Product Change Notification

PCN-IFC-8971-2023

Business Unit	Product Line Code	Type of Change	Action	Date of Issue
IFC - Industrial Field Connectivity	BF7	Product Change Notification	Notify Distributors and Field	10/4/2023

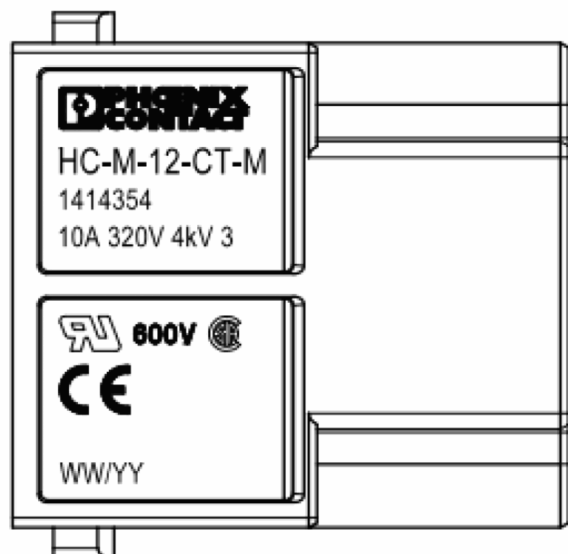
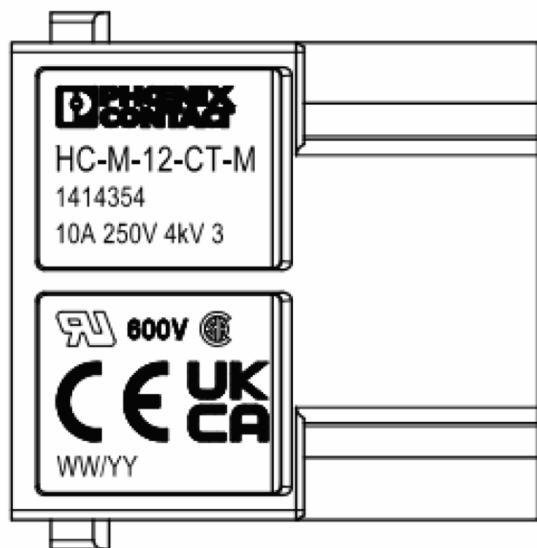
In an effort to ensure our modular inserts are used appropriately, we are updating the electrical characteristic printing on the 12pos modular crimp contact inserts to reflect Pollution Degree 3 instead of Pollution Degree 2. Pollution Degree 3 accounts for air pollution that could be conductive while Pollution Degree 2 is for only non-conductive pollution. As a result, the voltage limits identified on the insert reflect the worst-case scenario for Pollution Degree 3 (250V) instead of Pollution Degree 2 (320V). Both voltage ratings are still valid, but deciding which voltage is applicable will depend on the environmental conditions.
